Oil Conservation Division

LETTER OF VIOLATION - Inspection

BISON STATE No.001

BISON STATE No.002

BISON STATE # 2

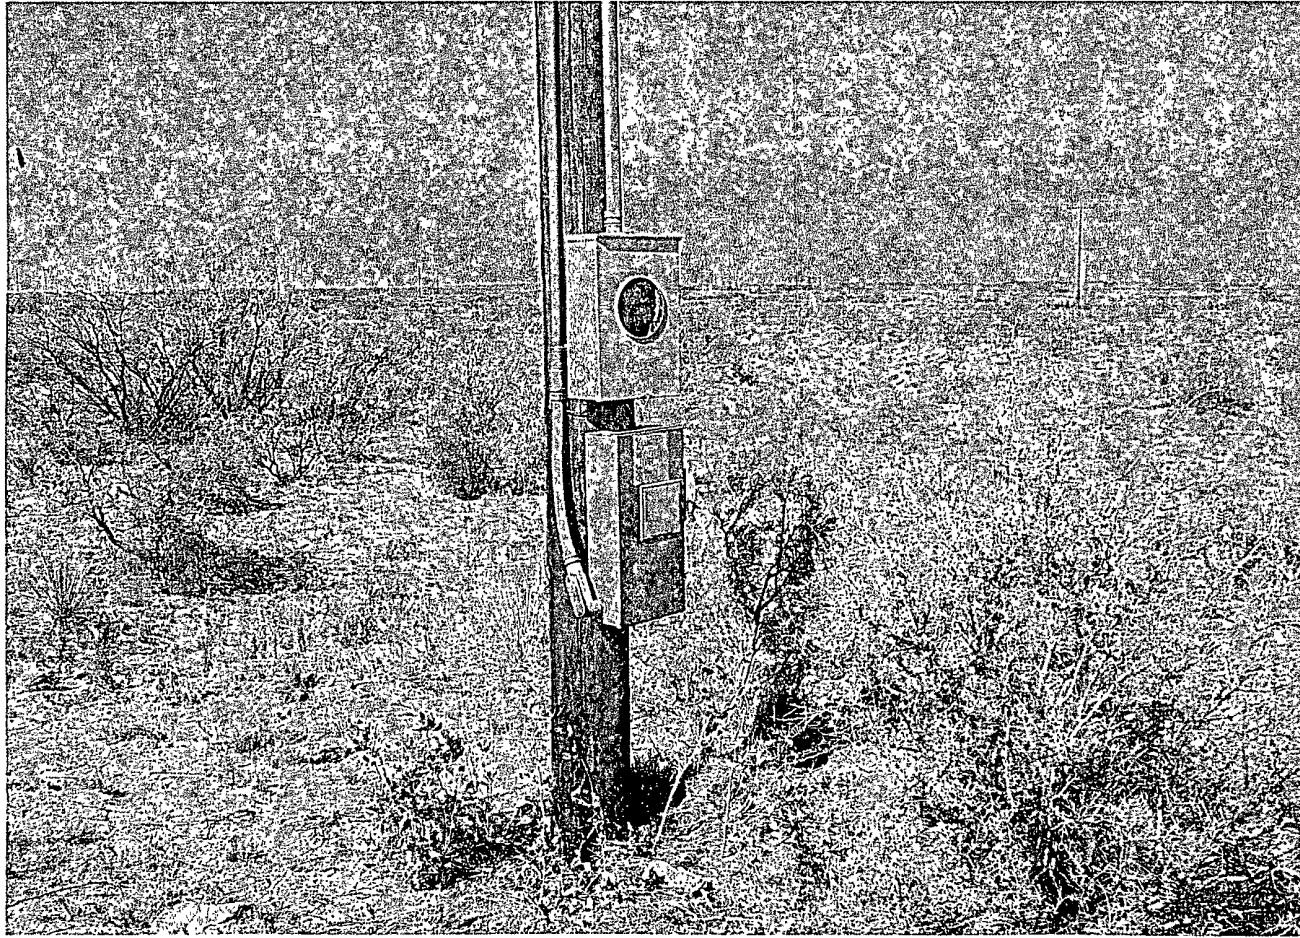
Comments on Inspection: DO NOT RELEASE. RULE 19.15.26.10. THE FOLLOWING MUST BE CORRECTED BEFORE THE WELL CAN BE RELEASED: NEED TO REMOVE MAIN DISCONNECT, METER BASE AND RISER, REMOVE WELL SIGN, REMOVE WIRE ROPE THAT RUNS FROM BISON STATE #2 WELL TO THE WEST ALONG ROAD TO THE BISON STATE #1 WELL. MARKER HAS CORRECT INFORMATION. THIS IS 1ST LETTER OF NON-COMPLIANCE. MGB.

MAIN DISCONNECT
CONDUIT, METER BASE

CHI BISON STATE # 2

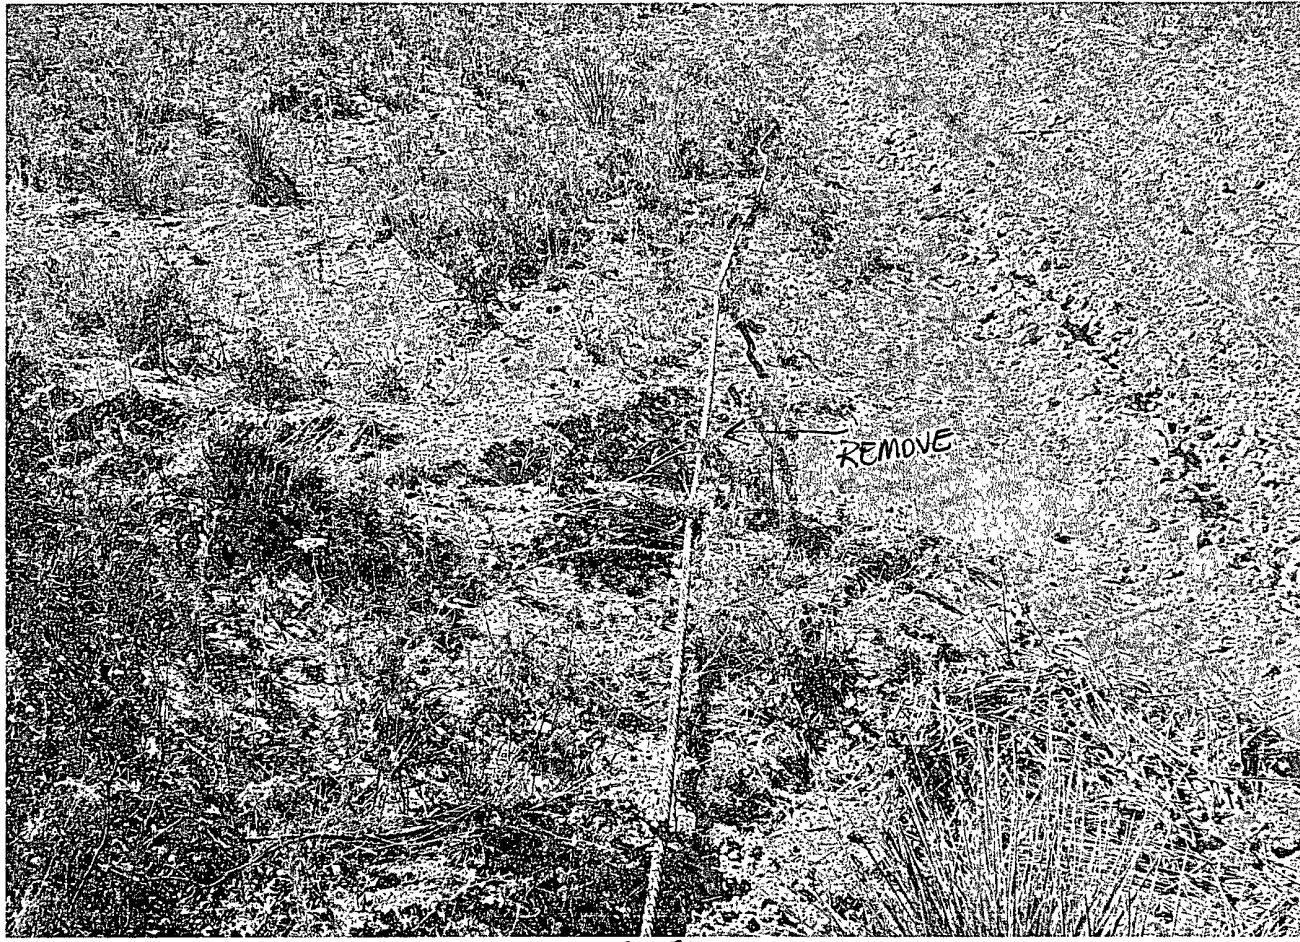
5" WIRE ROPE

REMOVE
